APPLICATION NO.	FILING DATE	FIRST NAMED INVENTOR	ATTORNEY DOCKET NO.	CONFIRMATION NO.
10/714,336	11/13/2003	Kenny Chang	JCLA11475	4087
23900	7590	06/16/2006	EXAMINER	
J C PATENTS, INC.			ARENA, ANDREW OWENS	
4 VENTURE, SUITE 250			ART UNIT	
IRVINE, CA 92618			PAPER NUMBER	
			2811

Office Action Summary	Application No.	Applicant(s)	
	10/714,336	CHANG ET AL.	
	Examiner	Art Unit	
	Andrew O. Arena	2811

DETAILED ACTION

FIG. 6

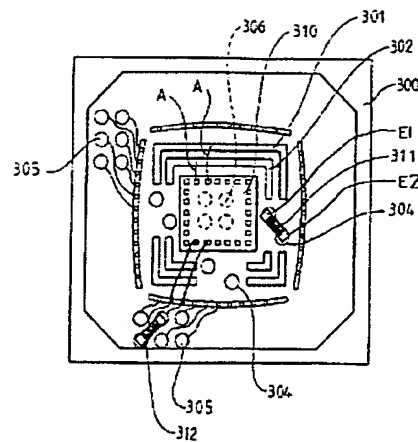
All rejections based on Tao refer to Fig 6, examiner has attached a copy of Tao Fig 6, to which has been added two reference numerals (E1, E2) used for clarity.

Regarding claims 24, 31, and 38, Tao discloses a package substrate (300; col 3 In 41) adapted to carry a die (310; col 3 In 46-48) of a wire bonding type (A; col 3 In 37-38), the package substrate at least comprising:

- a substrate (300; col 3 In 41) having a surface, a power pad (301; col 3 In 45-46) and a ground pad (302; col 3 In 46), wherein [, on] the surface of the substrate having a die bonding area, the power pad and the ground pad [are] disposed outside the die bonding area (301 and 302 are outside area 310);

- at least one passive component (311; col 3 In 42 - see Fig 5) disposed between the power pad and the ground pad (clear in Fig 6), the passive component having a power electrode (E2) connected to the power pad and a ground electrode (E1) connected to the ground pad (col 3 In 44-46);

- a first continuous layer on the exposed surface of the power electrode and the exposed surface of the power pad (col 3 In 44; Fig 1: terminals of 102); and

- a second continuous layer on the exposed surface of the ground electrode and the exposed surface of the ground pad (col 3 In 44; Fig 1: terminals of 102).
